EVEN Hotels + Staybridge Suites

DESIGN REVIEW | RECOMMENDATION MEETING | JUNE 3, 2015

Project #s: 3016993 and 6399557

RESPONSE TO RECOMMENDATION MEETING COMMENTS

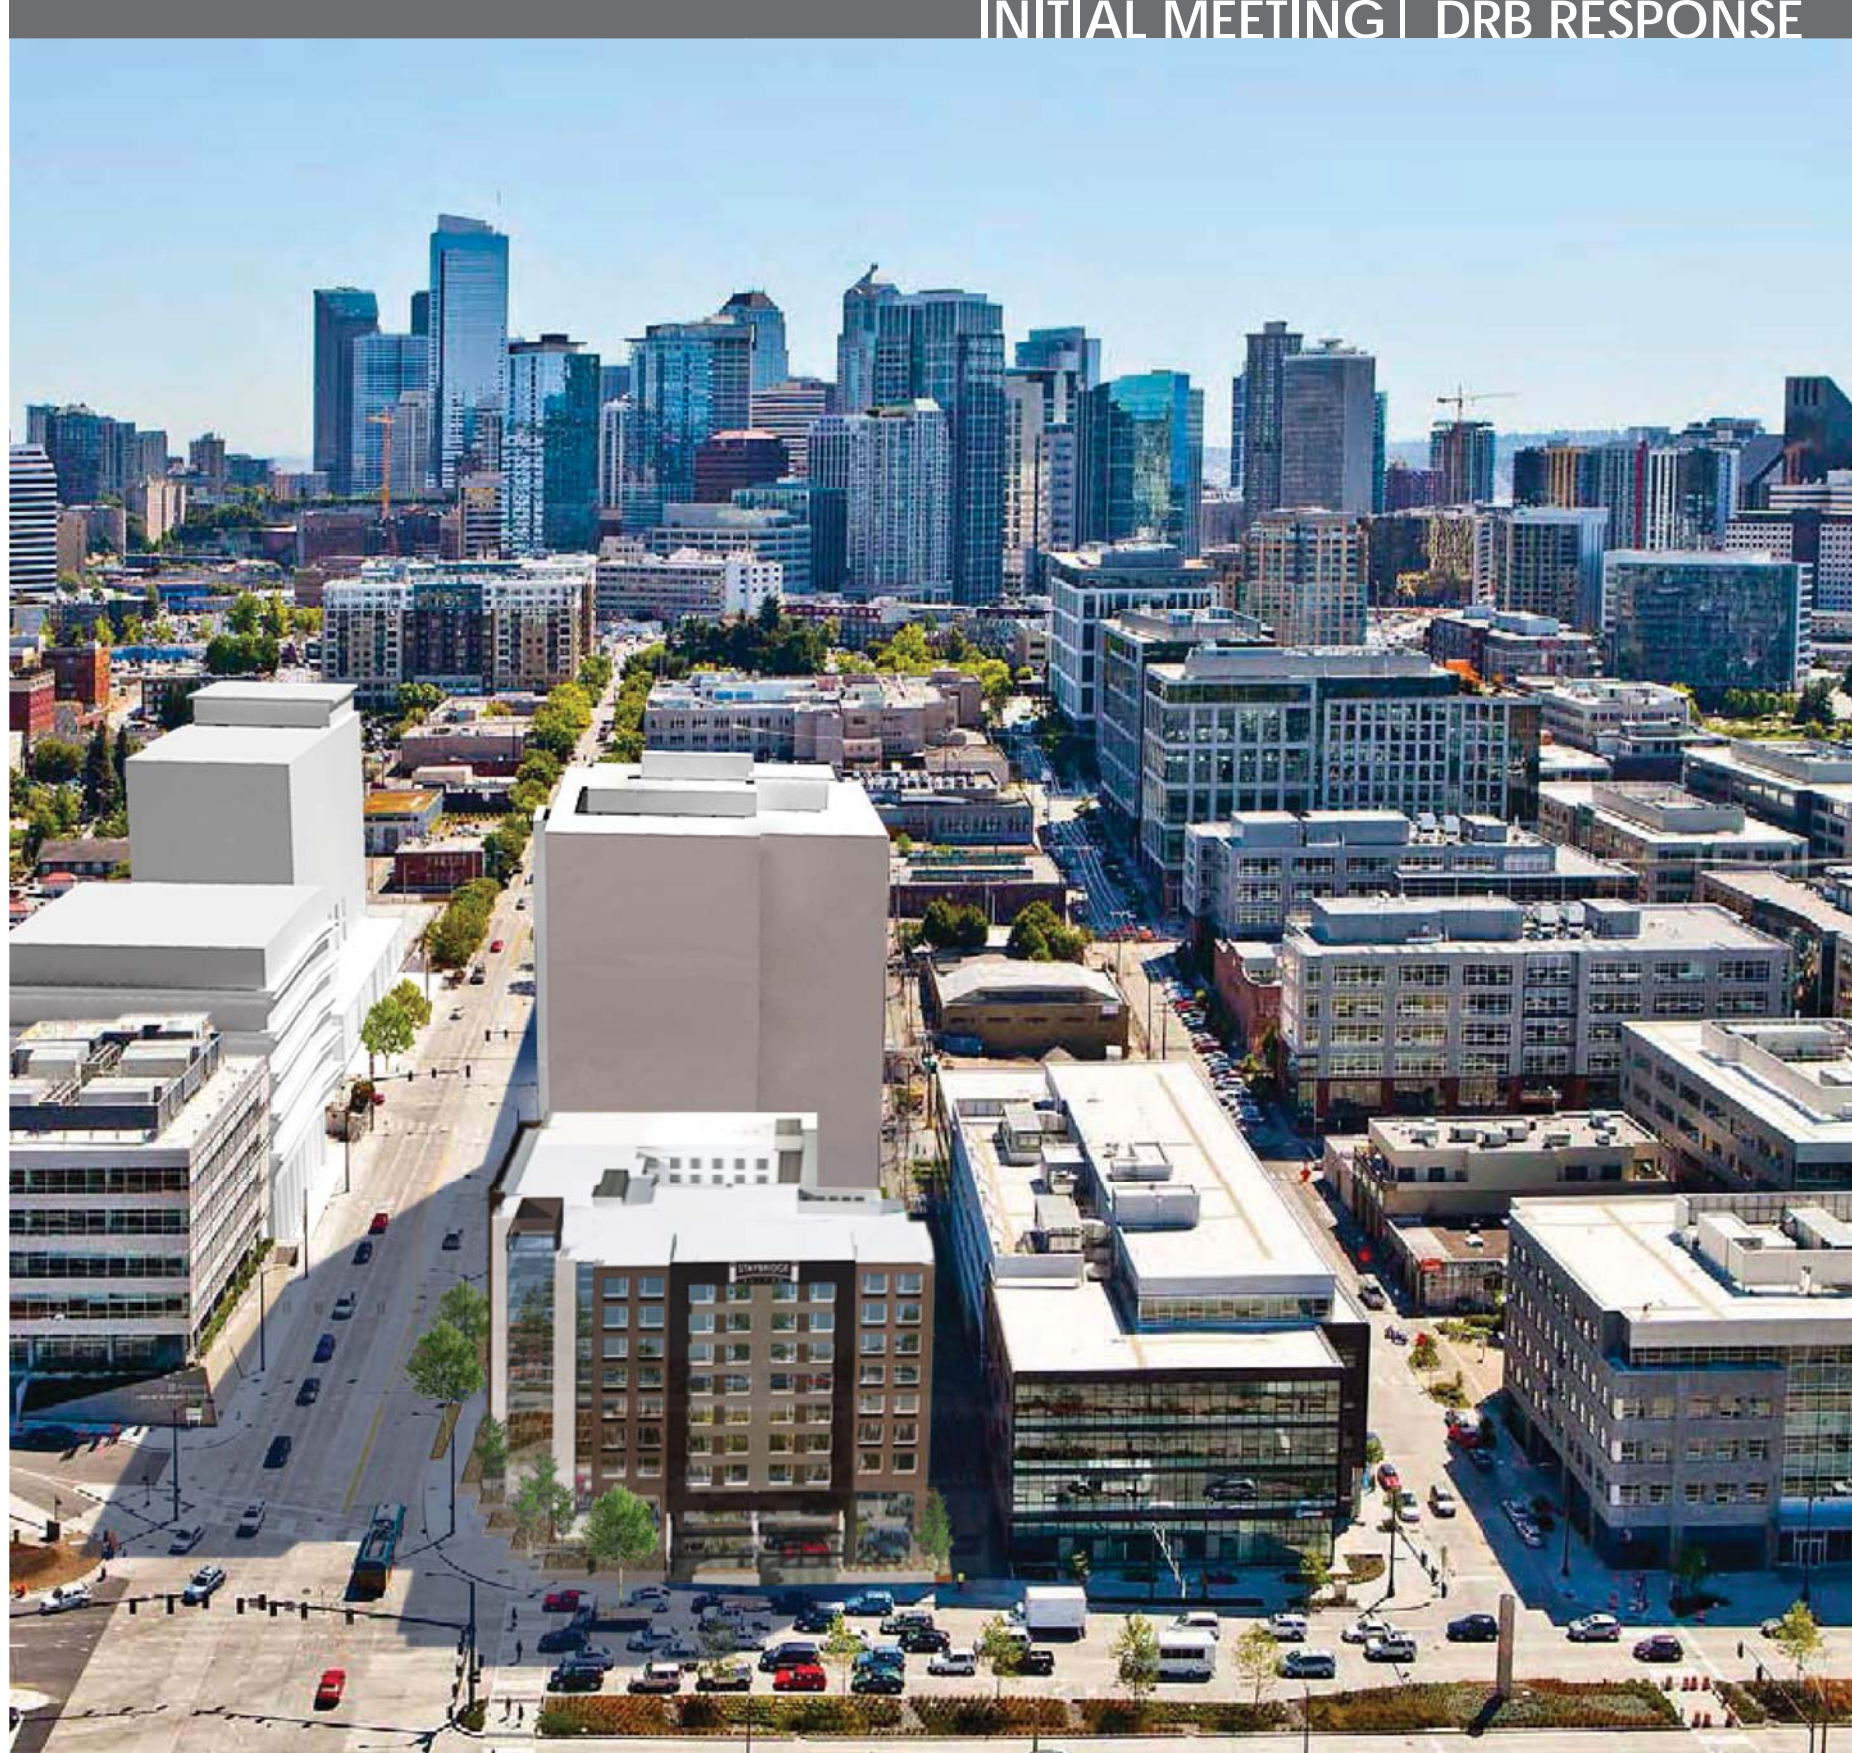
1. Massing: The Board noted that given the location of the site, the building should make a strong architectural gateway statement. The site can also be looked at as a 'bookend' to development along Fairview Ave N to the south and along Mercer Ave to the west. The Board expressed their concern that the proposed massing concepts were too muted to achieve a significant gateway statement. The Board offered the following additional guidance related to massing: (CS2.A.2, CS2.C.1, CS2.I.iii, CS3.B.1)

- a. Study and respond to the existing conditions of the surrounding buildings, especially 500 Boren to the west. (CS3.A.3, DC2.C.3)
- b. Design the corner joining the two wings to be dynamic. (See example #2 shown on page 6 of the EDG packet.) (CS2.C.1)
- c. Avoid a patchwork approach to the massing, the design should not look like infill but should be well integrated into the current massing. (CS3.A.3)
- d. Consider designing the massing to indicate the project is two different hotels using the corner as a transition. (DC1.A.1)
- e. Consider the stepping of the roof line as shown in Option 2. (DC2.B.1)

The corner feature has been strengthened to create a stronger feature and a neutral connector between the two facades. Strong lighting will be used to emphasize gateway statement along with a terraced base structure bringing landscape features further up the facade. Massing vocabulary has been changed and reinforces the two distinct hotels. Position of the building has been modified stepping back along Mercer to align with 500 Boren to the west – allowing for an activated plaza while extending the streetscape. The vocabulary of the adjacent 500 Boren structure to the West consisting of a landscape foreground and transparent façade have been incorporated into the Mercer Street facade.

NW STREET-LEVEL PERSPECTIVE
from Mercer Street

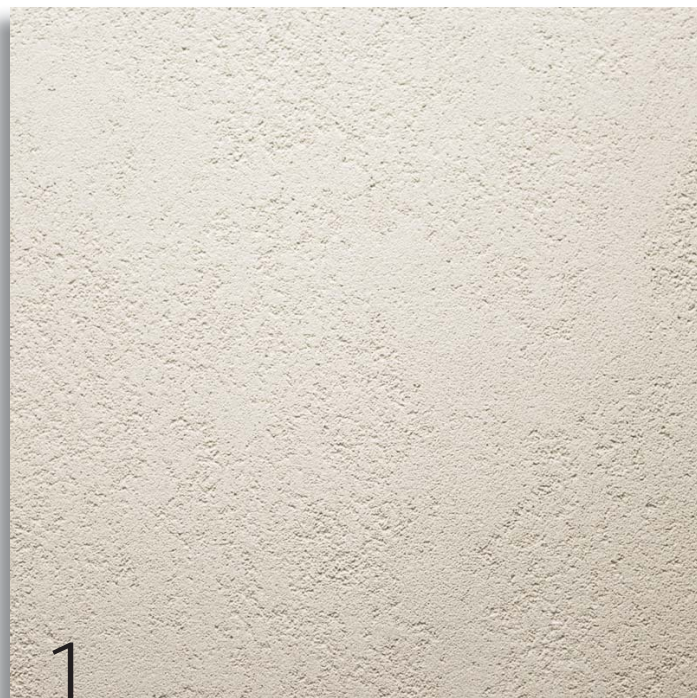
3. Materials: The Board noted that the recent buildings along the south side of Mercer St provide their relief and interest through the use of materials. The proposed concepts appear to be too plain for this gateway location. The Board strongly encouraged the use of quality materials that relate to the recently built structures along Mercer St. and Fairview Ave N. (DC4.A.1, DC2.C.3)

- a. Use quality exterior materials, with refined detailing. (DC4.A.1)
- b. Study and respond to the existing conditions of the surrounding buildings, especially 500 Boren to the west. (DC2.C.3)
- c. Design the scale of the signage to work with moving vehicles. (DC4.B)

Quality of the materials have increased and are more consistent with buildings along Mercer Street consisting of metal panels with a tone on tone pattern along with more transparency via strong glass statements at both the Mercer and Fairview levels incorporating an extended plaza along Mercer Street.

SIGNAGE PLAN
Scale:

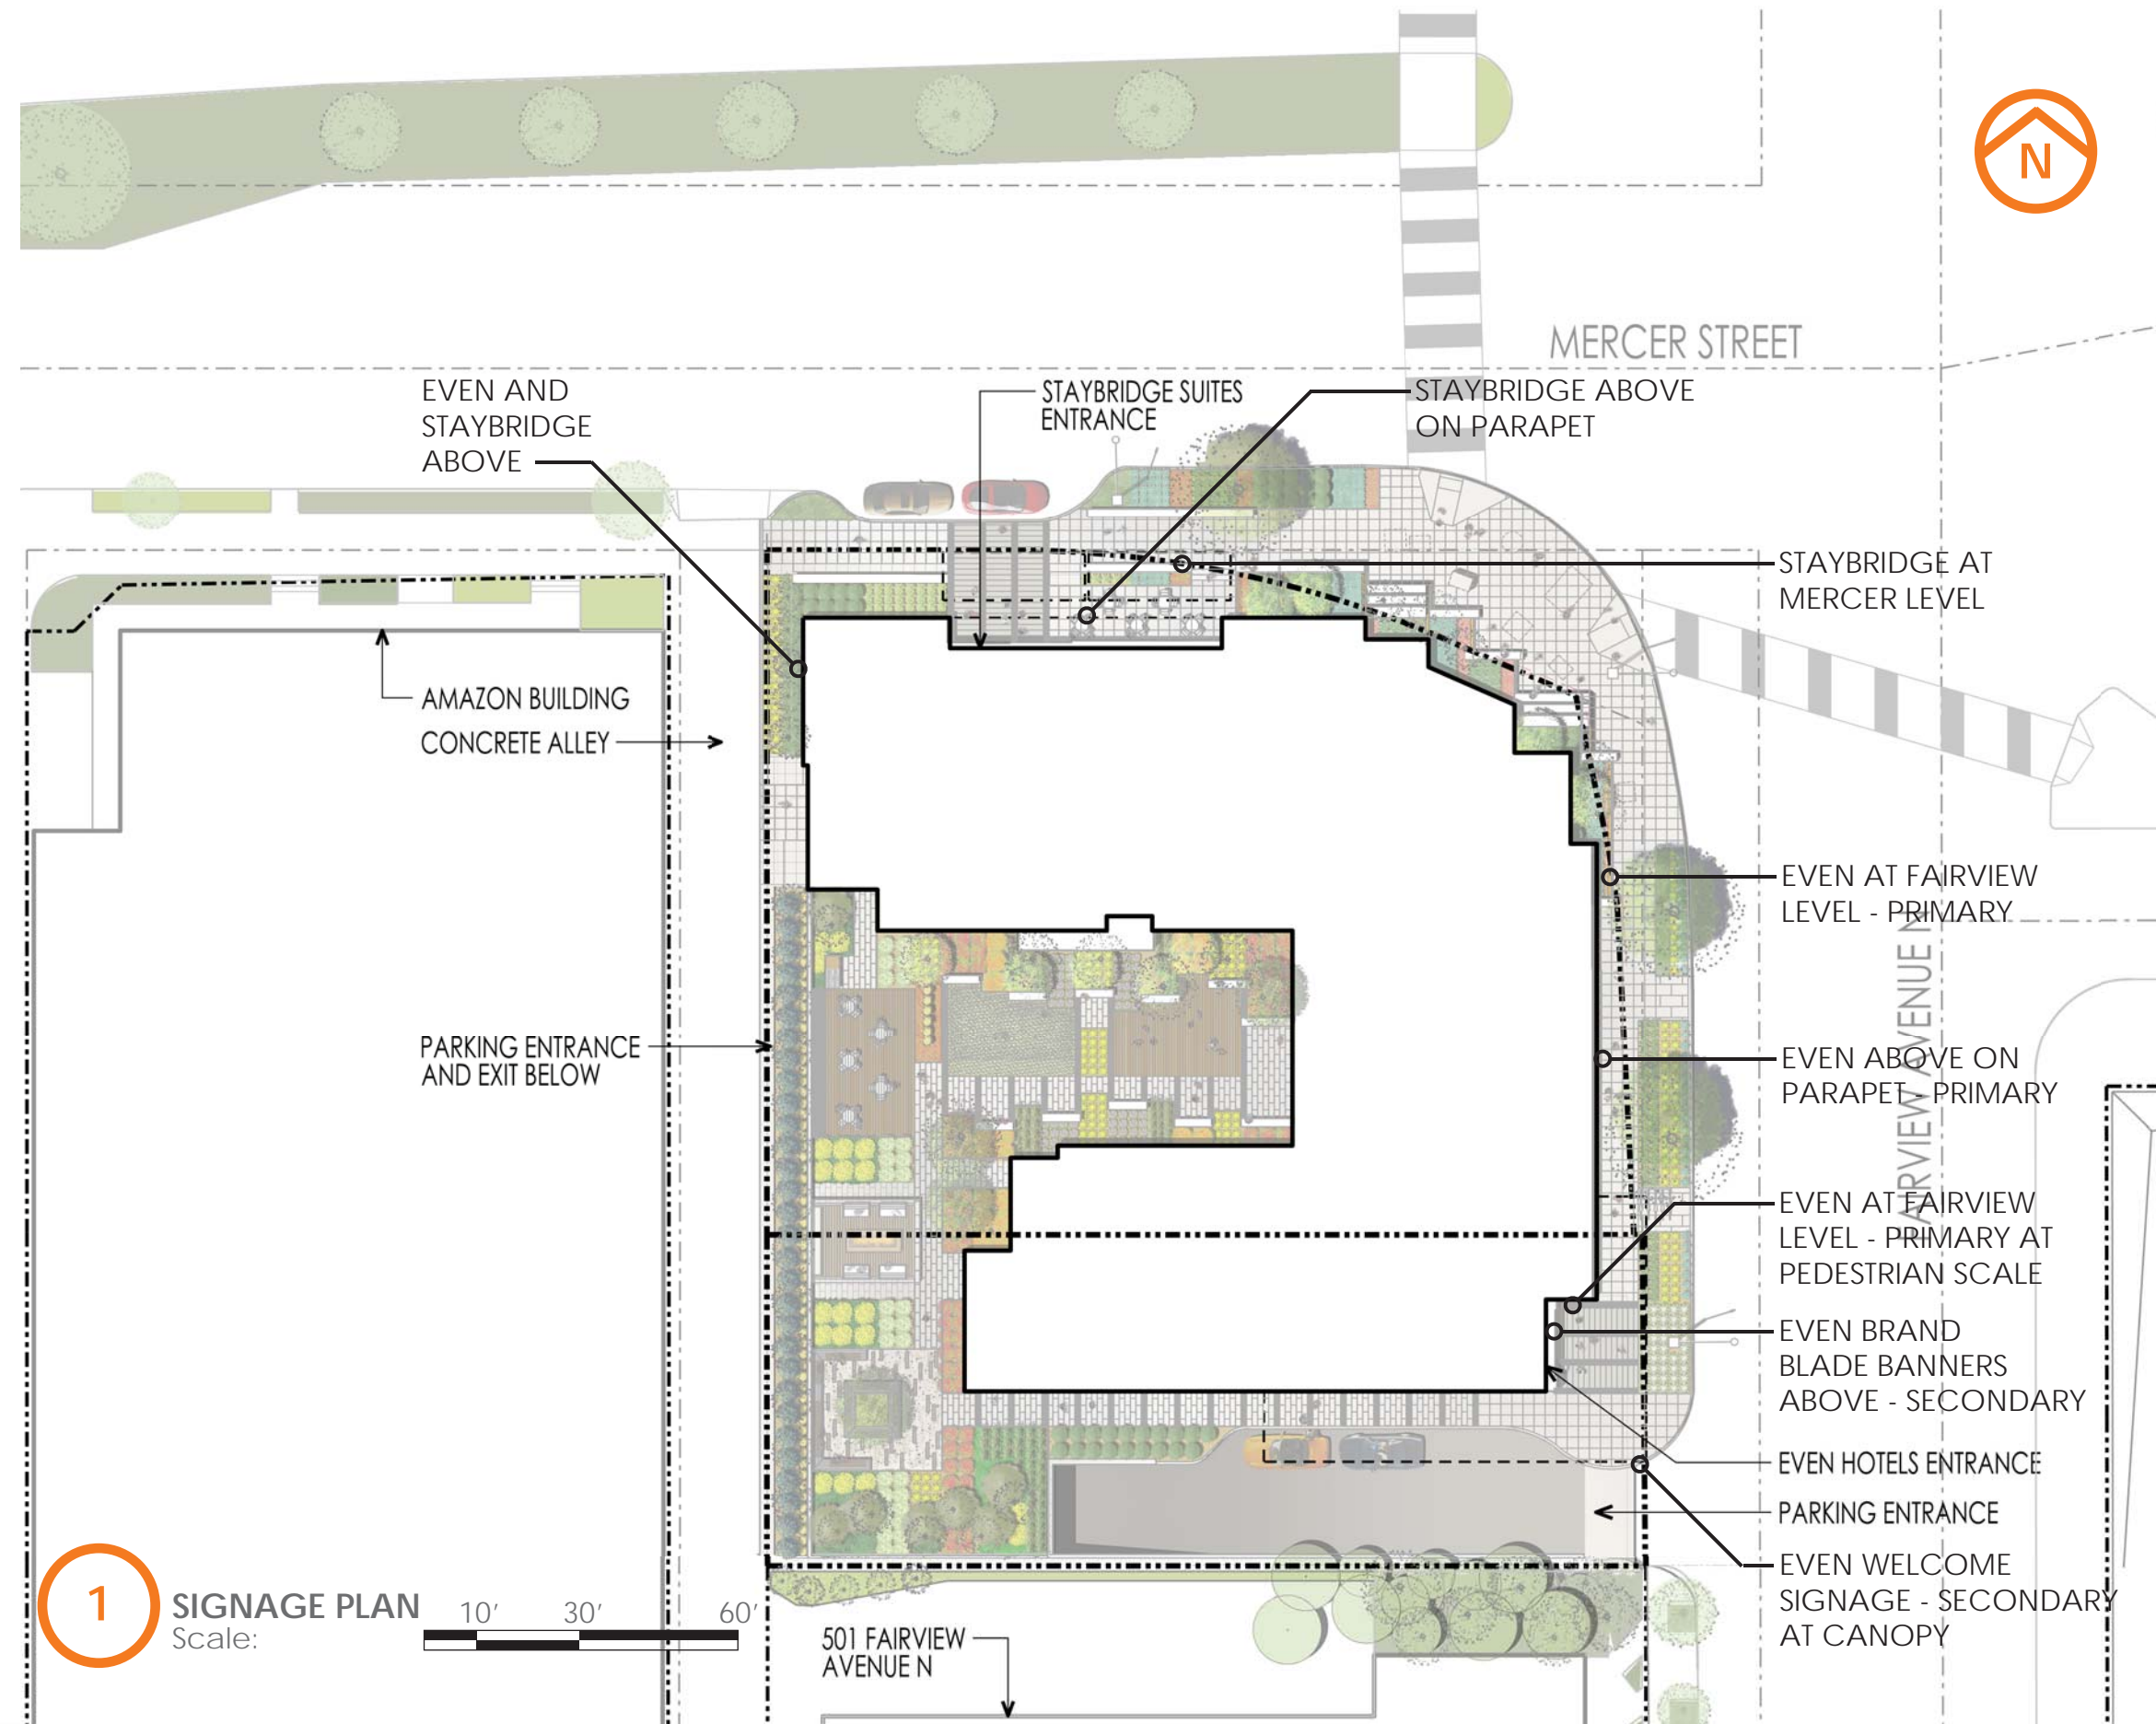
5. West Elevation: The Board noted that the west elevation needed further design.
 - a. Add transparency to the blank portions at the upper levels. (DC2.B.1, DC2.B.2)
 - b. Wrap the transparency at grade into the alley. (PL2.B.3)
 - c. Provide smaller signage at the lower level for way-finding, instead of near the roof line. (DC4.B.2)

Signage on the west façade has been repositioned and rescaled to be more in keeping with the location. Transparency has been added along the corner over the entire height of the tower as well as the ground level alleyway.
